UNITED STATES PATENT AND TRADEMARK OFFICE

APPLICATION NO.	FILING DATE	FIRST NAMED INVENTOR	ATTORNEY DOCKET NO.	CONFIRMATION NO.
10/585,722	06/26/2008	Peter Georg Laitenberger	568-PDD-03-13-US-[58P]	7200
69683	7590	06/24/2011		
C. R. Bard, Inc. Bard Peripheral Vascular, Inc. 1415 W. 3rd St PO Box 1740 Tempe, AZ 85280-1740			EXAMINER WOZNICKI, JACQUELINE	
			ART UNIT 3774	PAPER NUMBER
			NOTIFICATION DATE 06/24/2011	DELIVERY MODE ELECTRONIC

Office Action Summary	Application No. 10/585,722	Applicant(s) LAITENBERGER ET AL.	
	Examiner JACQUELINE WOZNICKI	Art Unit 3774

DETAILED ACTION

Annotated Figure 10

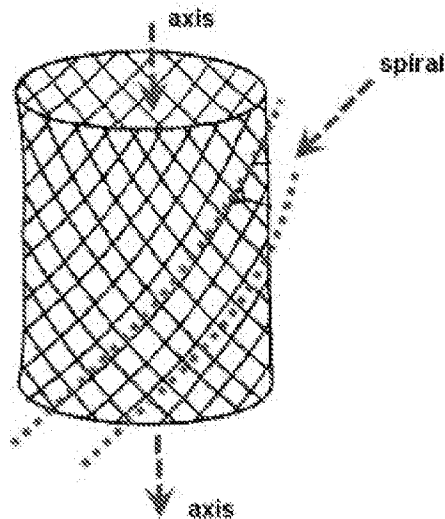
a tubular metal stent (Figure 3 (tubular); Abstract (metal); [0018] (stent)) defining a lumen centered on a central longitudinal axis (Annotated Figure 10; “axis”), the stent being radially expansible from a radially compact delivery configuration to a radially larger deployed configuration ([0114]),

a tubular metal stent (Figure 3 (tubular); Abstract (metal); [0018] (stent)) defining a lumen centered on a central longitudinal axis (Annotated Figure 10, "axis"), the stent being radially expansible from a radially compact delivery configuration to a radially larger deployed configuration ([0114]),

Regarding **claim 6-7 and 9-10**, Gray discloses each of the loops wrapping around an axis in the form of a spiral (Annotated Figure 10), wherein each of the loops wraps around the axis in a path that spirals around the axis from one end of the implant to the other (Annotated Figure 10), but fails to disclose the loops wrapping with an integral whole number of turns, the number of turns being at least three, and the pitch of the spiral being constant.
